Chart 400, Block D, 678
 (ADDRESS UNASSIGNED)

PROJECT NAME THE
 JORDAN JOB
 RAY STREET
 PORTLAND

SCALE 1/4" = 1'-0"
1ST FLOOR PLAN

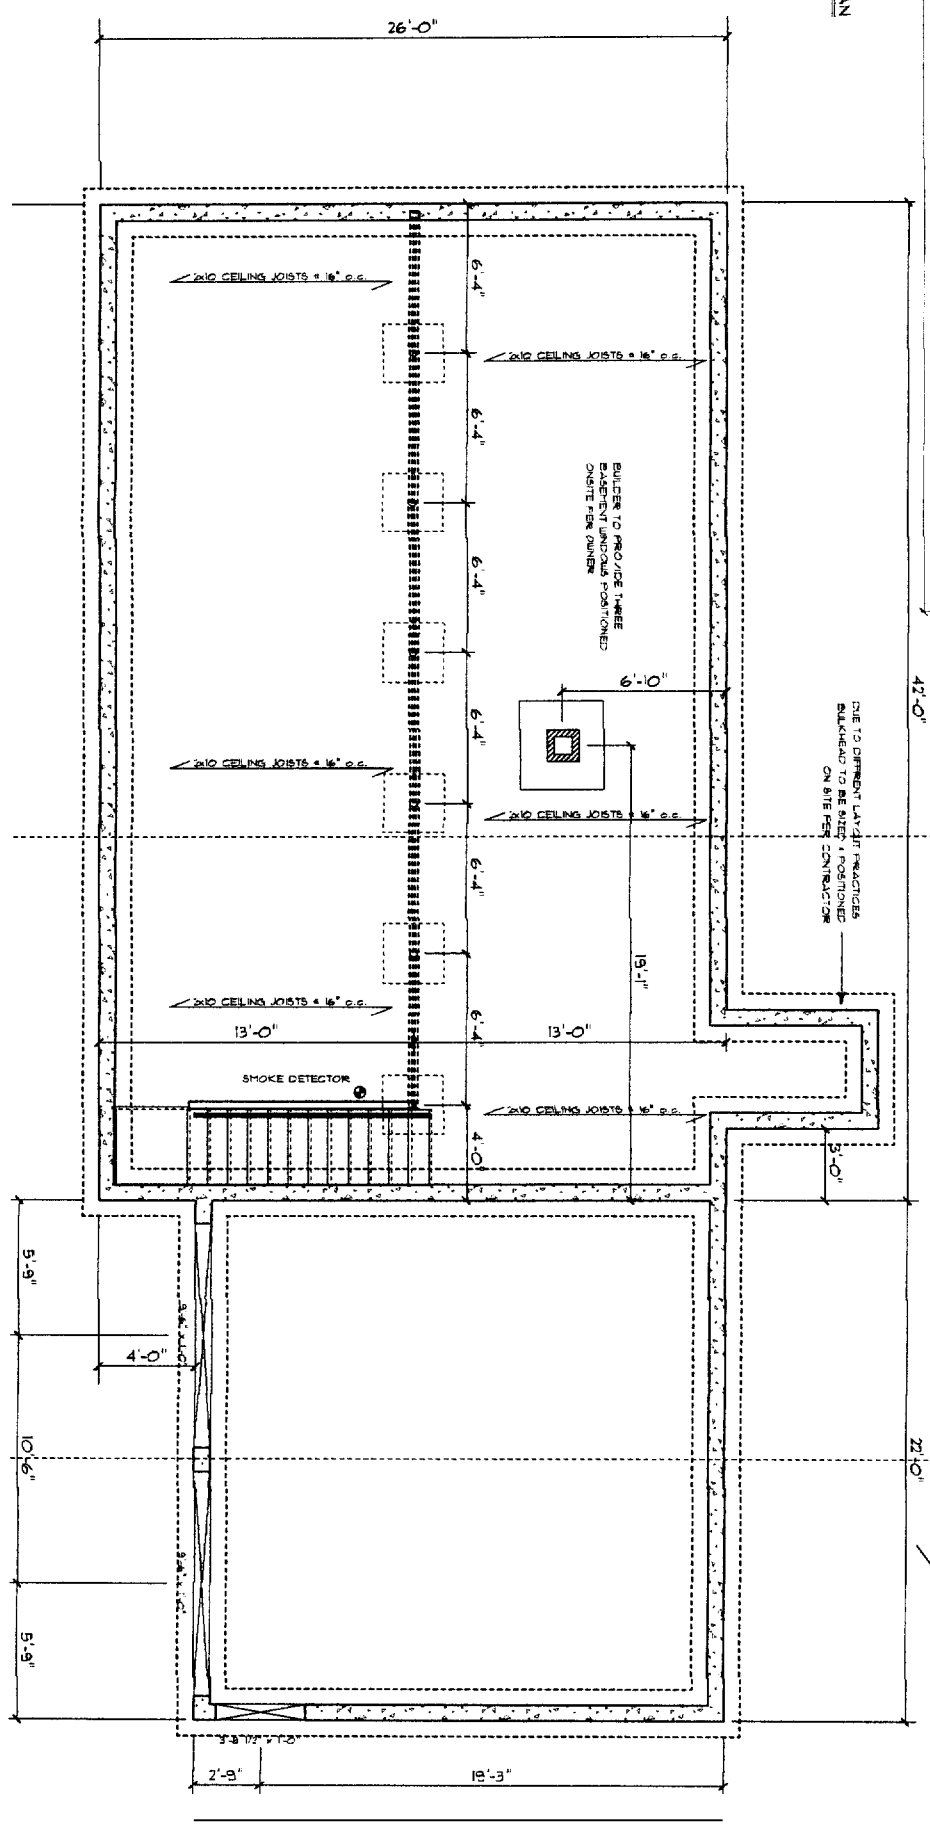
Attic
Seattle
Per G.M. 7/1/04
22x30

Per Greg M.
7/1/04
Temp

2 1/2" Gal.
Per G.M.

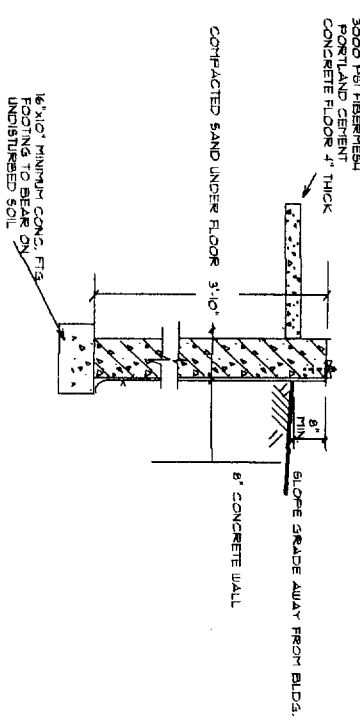
7/1/04
Per Greg M.
3-2x12
will be
of LV's
1x16 LV's
